BEFORE THE
Federal Communications Commission
WASHINGTON, D.C. 20554

In the Matter of)
)
ViaSat, Inc.) File No. SES- LIC-20120427-00404
) Call Sign E120075
Application for Authority to Operate Up to)
4,000 Transmit/Receive Aeronautical-Mobile)
Earth Stations in the Ka-band)

REPLY COMMENTS OF ROW 44, INC.

Technical Appendix

Mantarray M40 RHCP Measured Tx Antenna Pattern Cuts, Skew = 0, Freq = 28.6 GHz, Power = 30.5dBW/40k

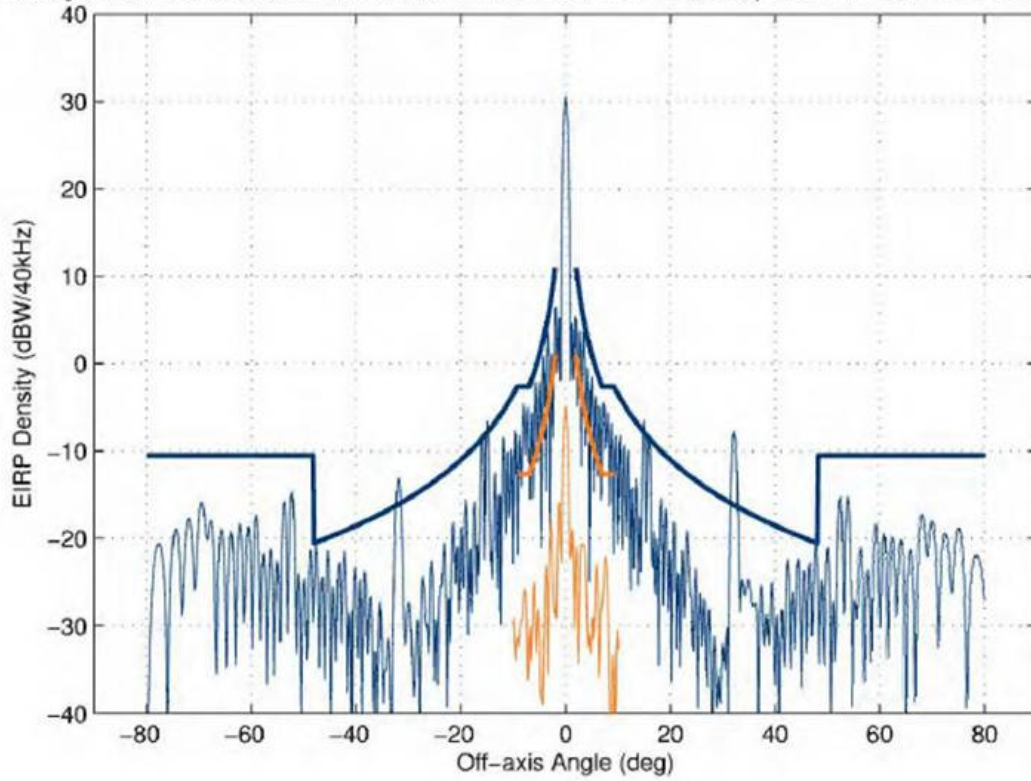
Figure 1, below, extracted from ViaSat's Application, plots the EIRP Density for zero degree antenna skew. The plot shows the first-order grating lobes at approximately +/- 32 degrees from center. As Row 44 stated in its Comments, the Mantarray antenna's unique horn spacing is specifically established for the purposes of eliminating grating lobes in the 0 degree skew plot. The very existence of such lobes in the plot casts doubt upon ViaSat's claims as to the antenna's design and repeatability of performance in large-scale manufacturing. If the antenna possessed the integrity claimed by ViaSat, there would be no, or very low-level, grating lobes present. As it is, the plotted grating lobes are of a magnitude that violates the Section 25.138 EIRP mask. See 47 C.F.R. §25.138. Considering this extensive deviation between intended design and actual performance, no conclusion can be made that ViaSat's antenna will achieve the claimed satisfactory performance.

The Commission must also keep in mind that, as Row 44 has previously indicated, the excessive grating lobe-levels of the Mantarray antenna are preventable by reducing the horns to a width of λ -c, vs. the Mantarray's value of 2λ -c. The inferior performance of the Mantarray Antenna is therefore neither a function of the laws of physics nor consistent with state-of-the-art design,

Mantarray M40 LHCP Measured Tx Antenna Pattern Cuts, Skew = 25, Freq = 28.85 GHz, Power = 30.5dBW/40k

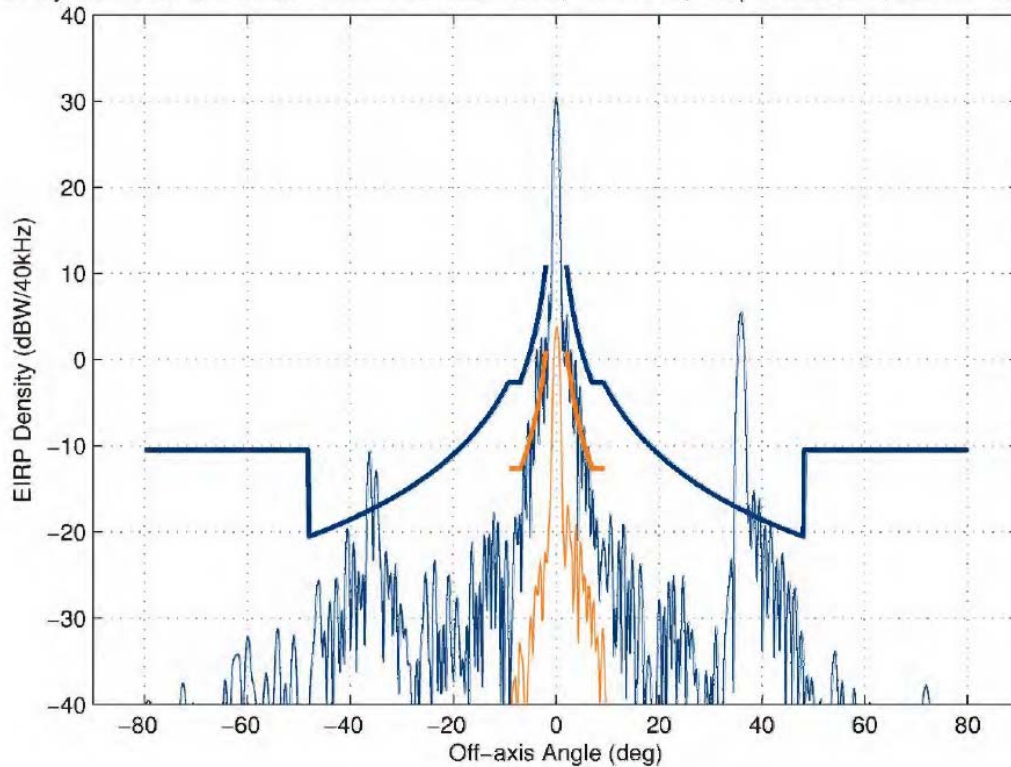
In addition, the impact of the grating lobes at zero degrees skew is substantially less than at higher skew values. The second plot below (Figure 2), also extracted from ViaSat's application, shows grating level exceedances at 25° skew, and also shows the substantial asymmetric nature (~ 15 dB) of the Mantarray antenna grating lobes. Also, grating lobe level variations of ~ 7 dB exist, for example, between ViaSat's LHCP EIRP spectral density plots at 28.35 GHz and 30 GHz. These types of deficiencies originate from the limitations of the Mantarray Antenna design. For example, in practice, the power dividers in the antenna's feed network will introduce a (frequency-dependent) phase shift between the signals in two (or more) arms. These phase shifts are very sensitive to manufacturing tolerances and, indeed, cause the significant asymmetries observed between the left and right sections of the plots.

Figure 3:

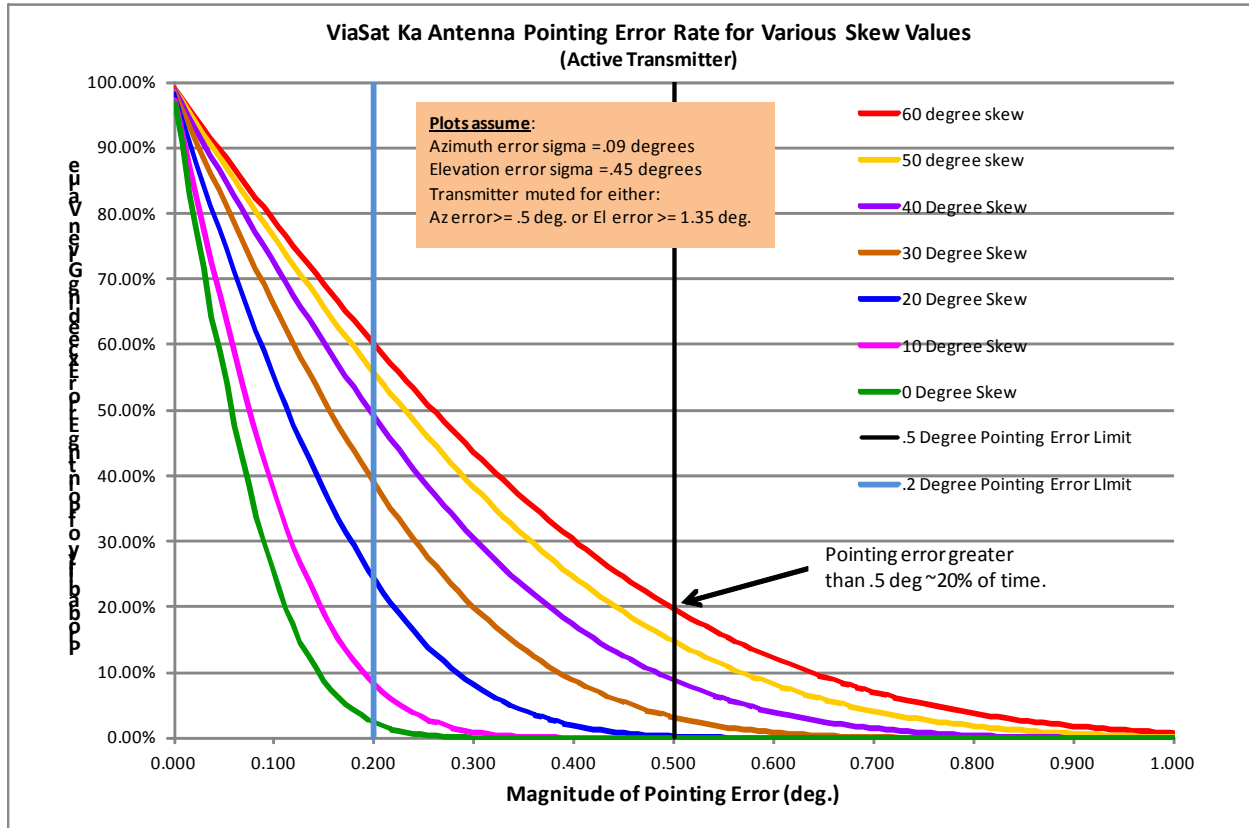
(That is, Row 44's total 'count' of the statistics of instances where the pointing error exceeds a given value did not include the 'count' of statistics of instances where the pointing error exceeded the same, but where ViaSat would disable its transmitter). Therefore, each trace in the plot below (Figure 3) represents the total time that the pointing error will exceed a given value while ViaSat's transmitter is active, compared to the total time that ViaSat's system is operating with either an active or inactive transmitter.

This analysis was performed for skew values between 0 and 60 degrees (i.e., the functional range claimed by ViaSat). The black vertical trace denotes the 0.5 degree pointing error limit. As another reference, the light-blue vertical trace denotes the 0.2 degree pointing error limit.

The plots portray the troubling nature of ViaSat’s approach, as the pointing error frequently exceeds 0.5 degrees. At 30 degrees skew, the brown trace indicates that the GSO arc pointing error will exceed 0.5 degrees ~3.5% of the time. For 40 degrees (purple), ~9% of the time. For 50 degrees (yellow), ~15% of the time. For 60 degrees skew (red), the .5 degree limit will be exceeded nearly ~20% of the time.
